# CITY OF ALBUQUERQUE

**RE: Montecito West Unit 1, Lots 1-46  
Grading and Drainage Plan  
Engineers Stamp Date 6/6/14 (D9D004)  
Certification Date 12/8/14**

Re: Grading and Drainage Certification, Montecito West Unit 1  
DRB Case No. 1009506, (D09/D004)

<b>CITY OF ALBUQUERQUE</b> PUBLIC WORKS DEPARTMENT	
<b>MONTECITO WEST UNITS 1 &amp; 2</b> GRADING AND DRAINAGE PLAN			
Design Review Committee	City Engineer Approval	Mo./Day/Yr.	Mo./Day/Yr.
City Project No. XXXXXX		Zone Map No. D-09-Z	Sheet 1 of 4

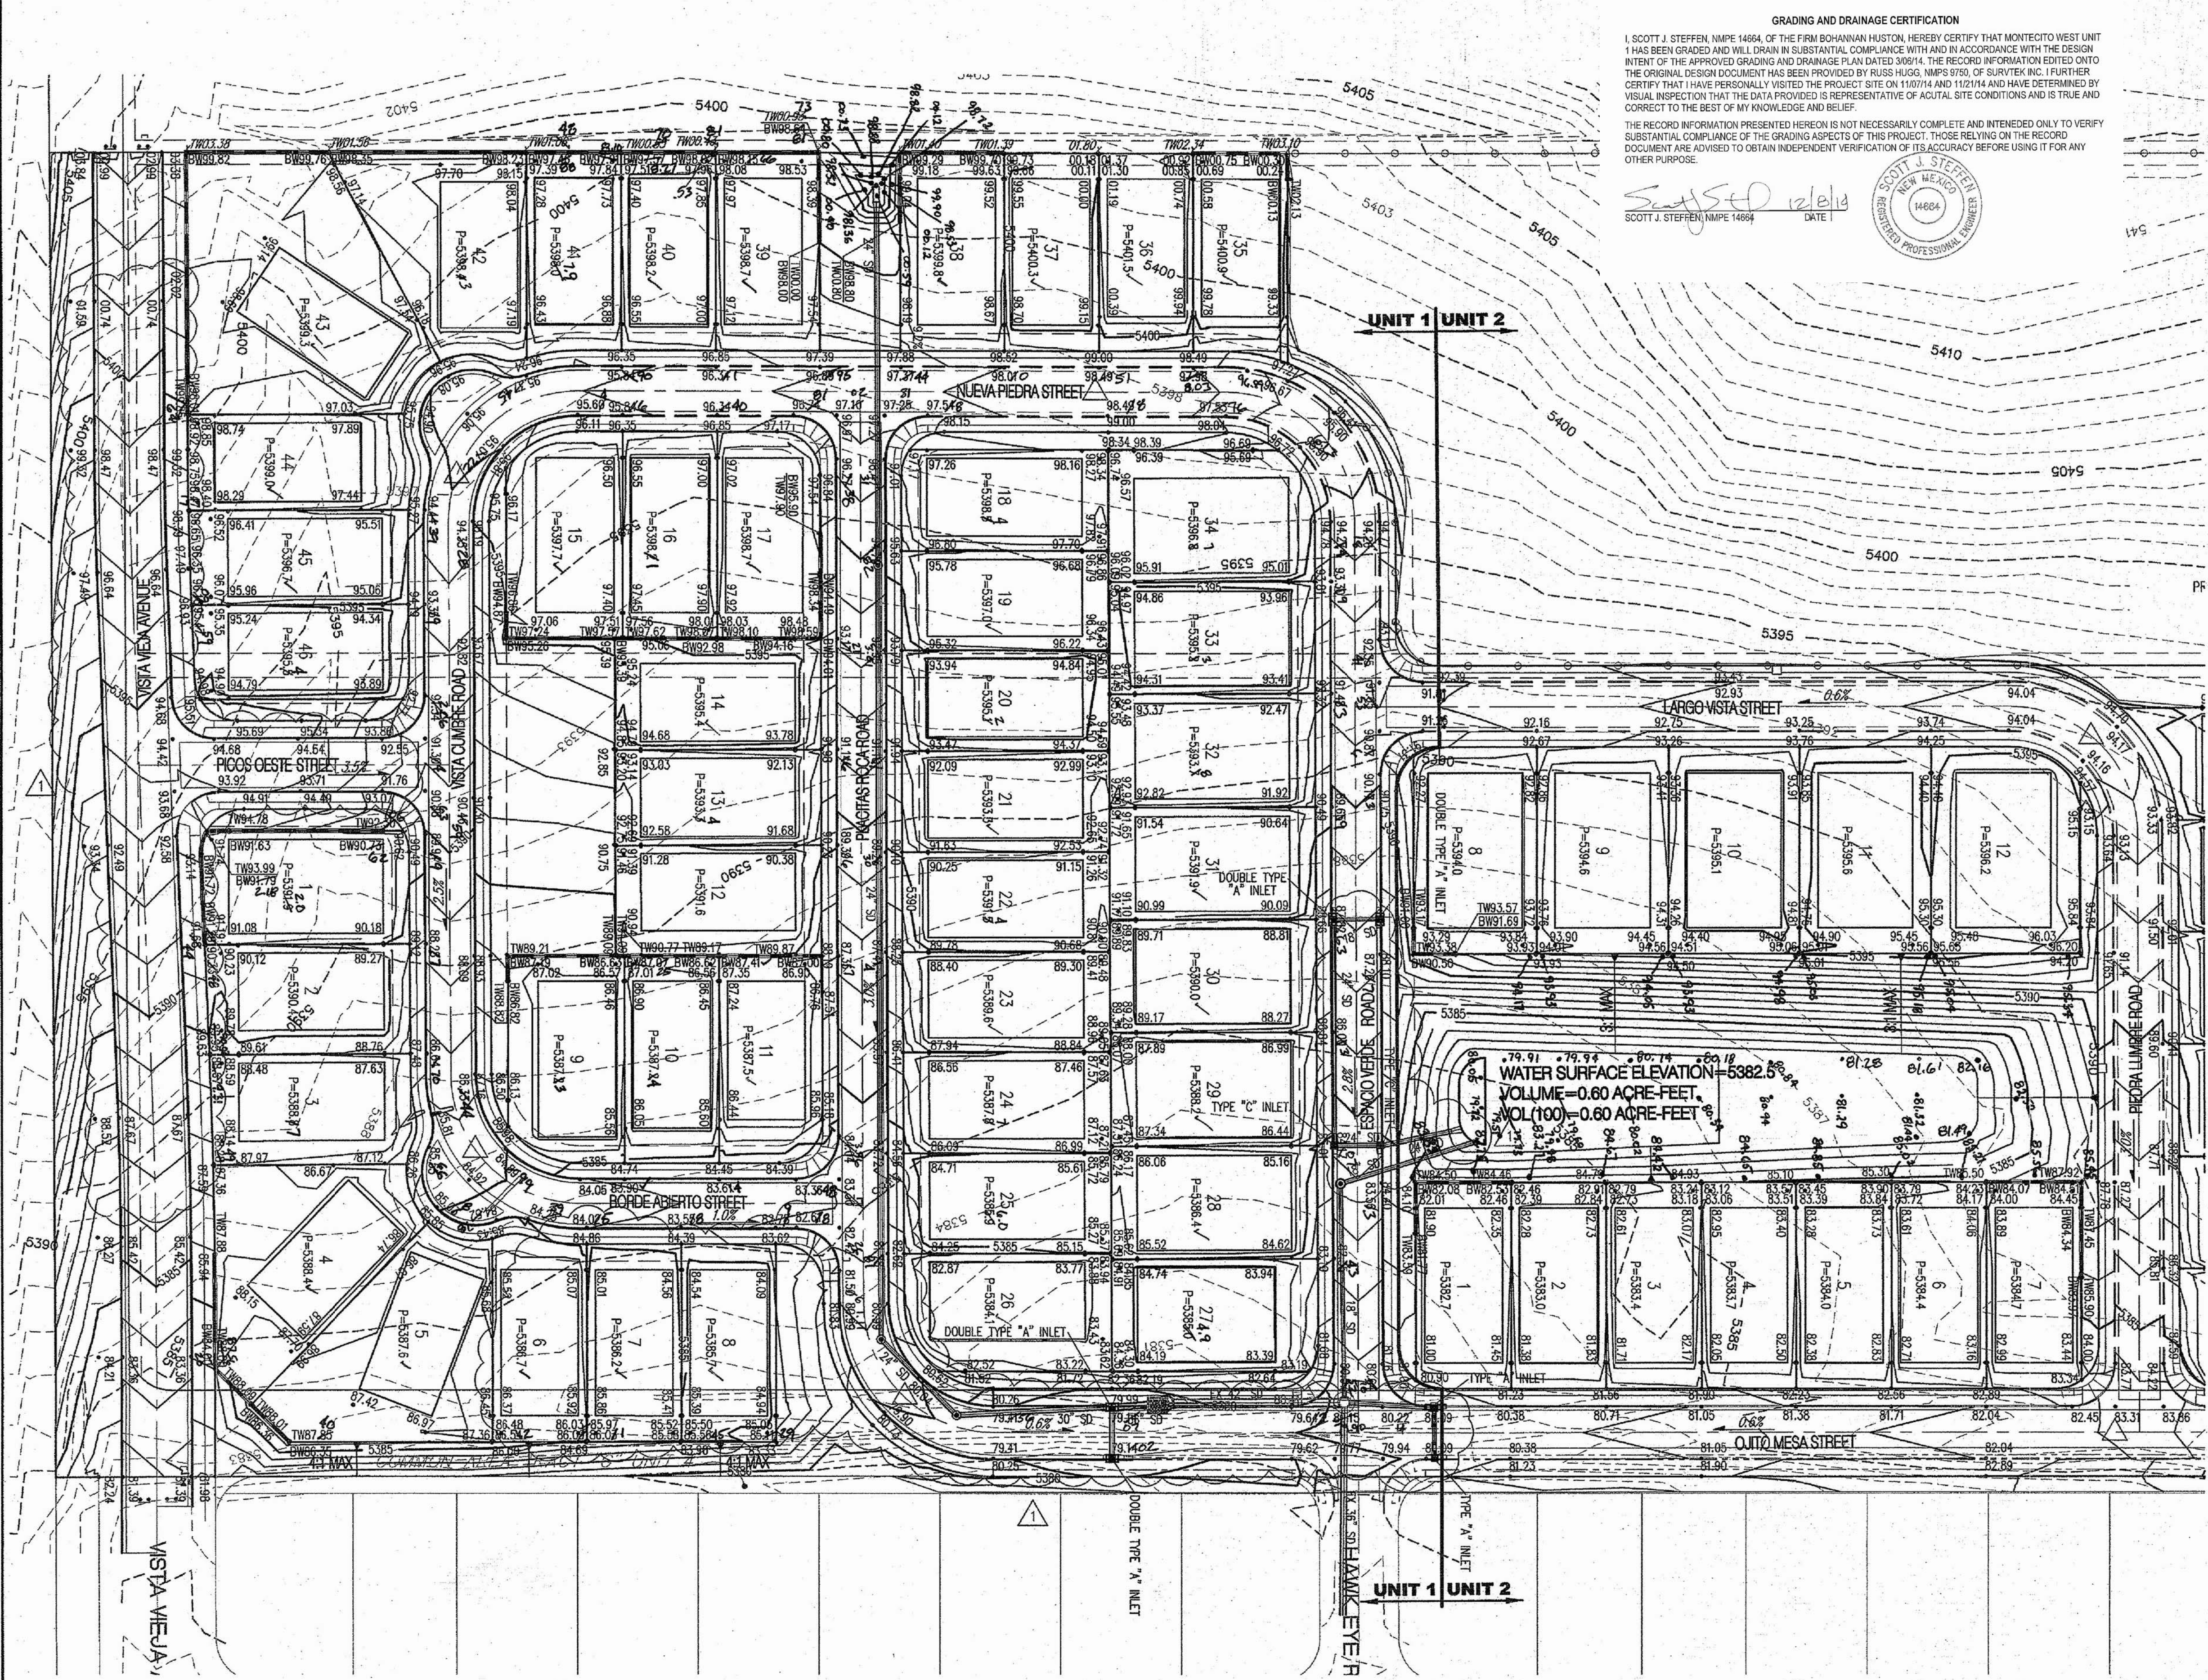
Hydrology realizes that rip-rap or similar was not specified at the end of the pipe between lots 38 and 39 on the approved Grading and Drainage Plan, but feels it would be helpful to prevent sediment from entering the pipe, would help prevent erosion and should improve the effectiveness of the storm drain.

Please mention to Pulte Homes that Hydrology is requesting rip-rap or similar in the depressed area at the pipe end. It is not a requirement for the approval of this request.
